ITEM FOR ENVIRONMENTAL COMMISSION AGENDA

COMMISSION MEETING	January 17, 2018
DATE REQUESTED:	
NAME & NUMBER OF PROJECT:	1704 and 1706 Channel Road SP-2017-0176D
NAME OF APPLICANT OR ORGANIZATION:	Janis Smith (512)914-3729
LOCATION:	1704 Channel Road, Austin, Texas
COUNCIL DISTRICT:	District # 10
PROJECT FILING DATE:	May 17, 2017
DSD/ENVIRONMENTAL STAFF:	Atha Phillips, Environmental Program Coordinator 512-974-6303, Atha.Phillips@austintexas.gov
WPD/ERM STAFF	Liz Johnston, Environmental Program Coordinator 512-974-2619, Liz.Johnston@austintexas.gov
WATERSHED:	Lake Austin
ORDINANCE:	Watershed Protection Ordinance
REQUEST:	Variance request is as follows: 1. To allow cut above 4' feet within Lake Austin. [25-8-341(A)]
STAFF DETERMINATION:	Staff does not recommend approval.
REASONS FOR DETERMINATION:	Findings of fact have not been met.

Project: 1704 and 1706 Channel Road
Ordinance Standard: Watershed Protection Ordinance
Variance Request: To allow cut above 4' feet within Lake Austin. [25-8-341(A)]

ATTACHMENT 3
PROPOSED CONDITIONS

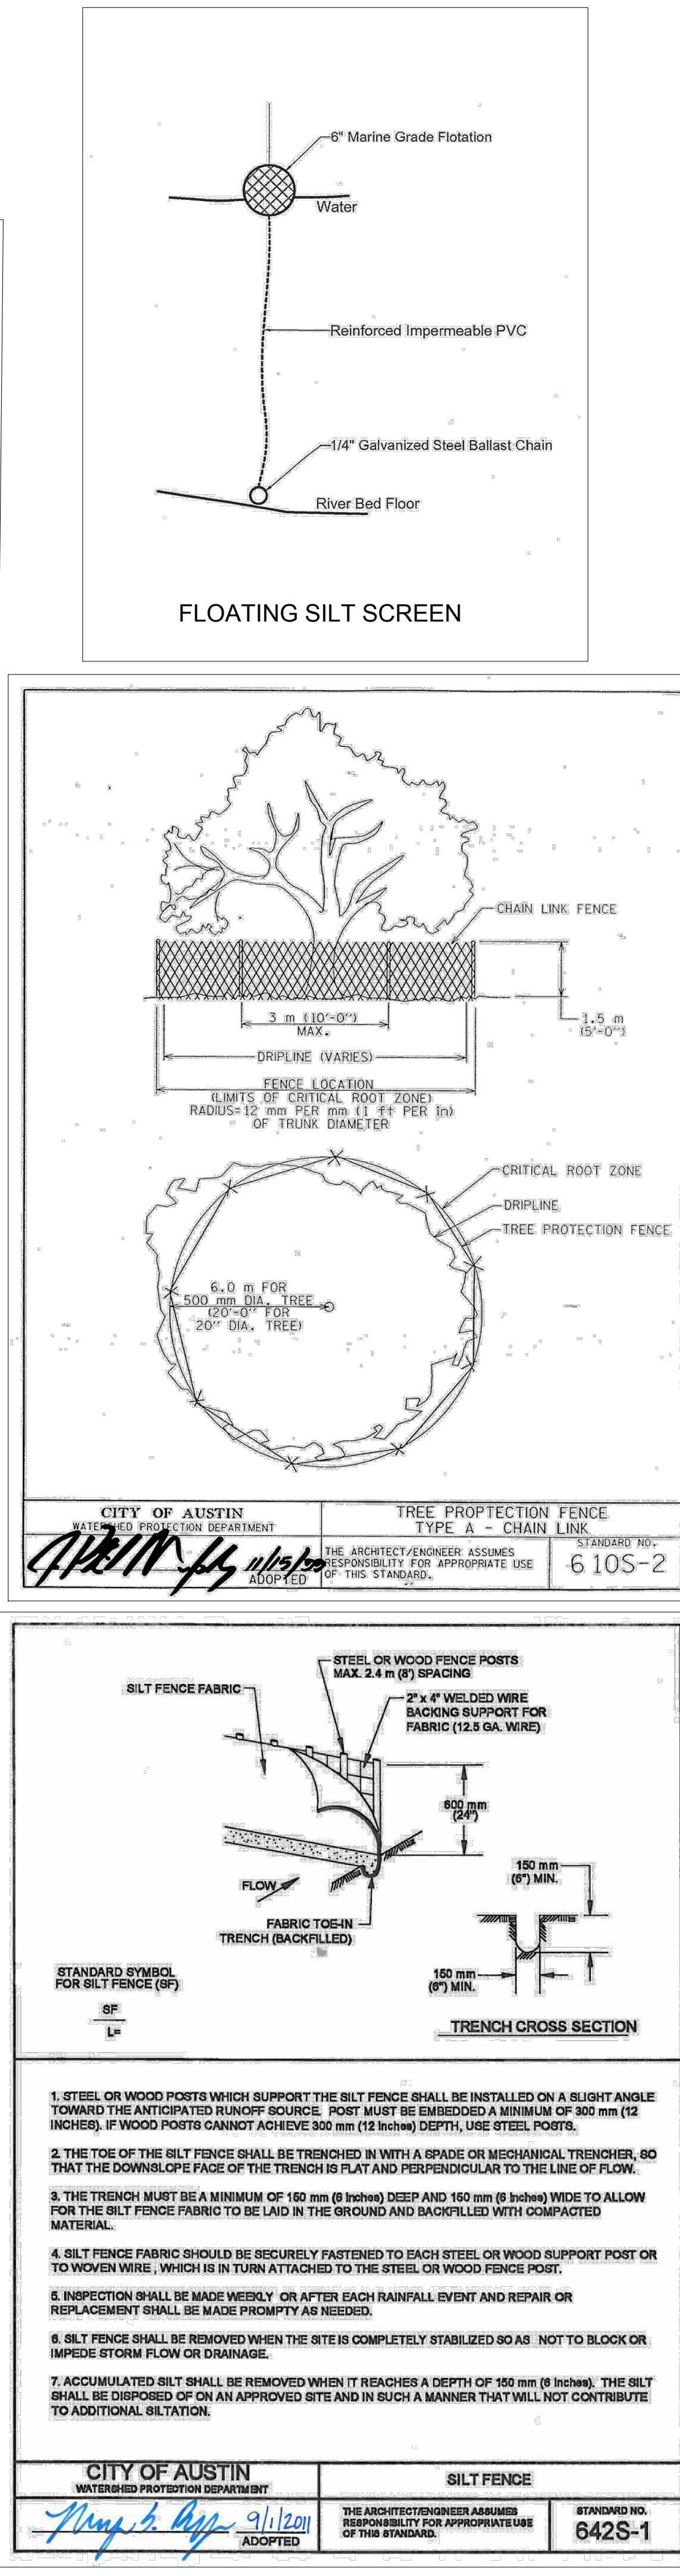
No, there is an existing cut in slip and other places along the shoreline that the boat dock could be located.

No, the development proposed is not based on a hardship but rather a preference for the boat dock location.

No, there is an existing cut in slip and other places along the shoreline that the boat dock could be located. It is unnecessary to deviate from code since other options exist.

Clearly indicate in what way the proposed project does not comply with current Code (include maps and exhibits)	<i>Enlarging the cut-in slip will require cut more than 4 ft. Attachment 3, Proposed Conditions, shows the cross-sections detailing the cut across the proposed cut-in slip. In order for a boat dock to house a ski boat and boat lift, it's necessary to have 3.5 ft of depth to accommodate the draft of the ski boat and cradle of the boat lift. The slip will extend into what is now land which is about 4 ft higher than the water surface elevation; so the depth of the cut is the sum of the height difference between the land elevation and the water surface elevation plus 3.5 ft. for the boat draft.</i>
---	---

YES. After receiving the first set of comments in the update process and meeting with COA staff, the project design was changed to comply with a staff recommendation to incorporate the existing cut-in slip in the location of the proposed boat dock on the channel. According to staff, doing so will “avoid an environmental variance that might not meet the Findings of Fact.” The recommendation and subsequent design change requires one variance.
